Access Compliance Report

Public Rights-of-Way

(Curb Ramps)

Intersection ID: 50708	Main Street: CELEBRATION_RD	Cross Street: BROTHERLY_LN	Location: SE
ADA ID: C1507DF426FD	Ramp Type: Perp	Initial Pass/Fail: Pass	Overall Compliance: No
Codes/Mitigation Info/Possible Solution		Field Measurements/Component Compliance	
Severity Score: 2.75

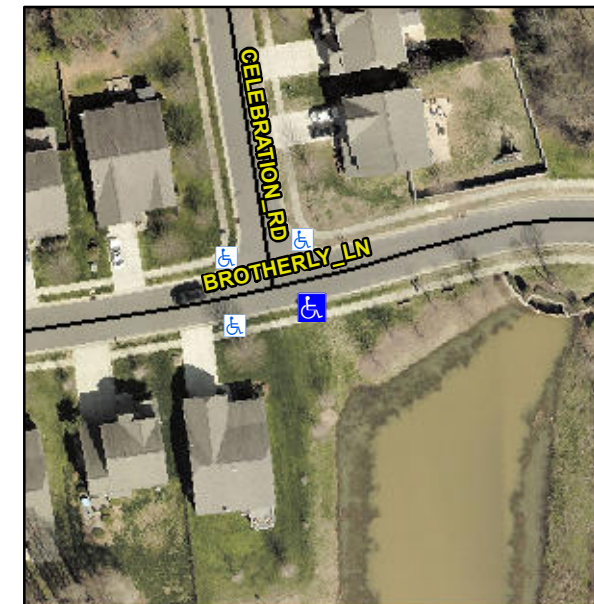
Remove & Replace Flare. Remove & Replace Gutter.

R304.2.3, R304.5.3

Compliance	Description	Data	Compliance	Description	Data
N/A	Ramp Length (in)	49.0	Yes	Ramp Slope (%)	7.7
Yes	Ramp Width (in)	48.0	Yes	Ramp XSlope (%)	2.7
N/A	Flare Type LT	Sloped	N/A	Flare Type RT	N/A
N/A	Flare Slope LT (%)	0.5	No	Flare Slope RT (%)	11.5
N/A	Flare Traversable LT?	Yes	N/A	Flare Traversable RT?	Yes
Yes	Landing Length (in)	48.0	Yes	DWS Provided?	Yes
Yes	Landing Width (in)	48.0	Yes	DWS Contrast?	Yes
Yes	Landing Slope (%)	0.3	Yes	DWS Length (in)	24.5
Yes	Landing X Slope (%)	3.7	Yes	DWS Full Width?	Yes
N/A	Landing Curb? (Y/N)	No	Yes	DWS Offset (in)	0.0
N/A	Shared Landing?	No			
Yes	Gutter Ponding?	No	Yes	Gutter Slope (%)	1.0
Yes	Gutter Lip Ht (in)	0.0	No	Gutter X Slope (%)	4.2
N/A	Painted X Walk1?	No	N/A	Painted X Walk2?	N/A
	X Walk 1 Direction	To N		X Walk 2 Direction	N/A
N/A	X Walk 1 Width (in)	N/A	N/A	X Walk 2 Width (in)	N/A
	X Walk 1 Slope (%)	2.2		X Walk 2 Slope (%)	N/A
	X Walk 1 X Slope (%)	3.9		X Walk 2 X Slope (%)	N/A
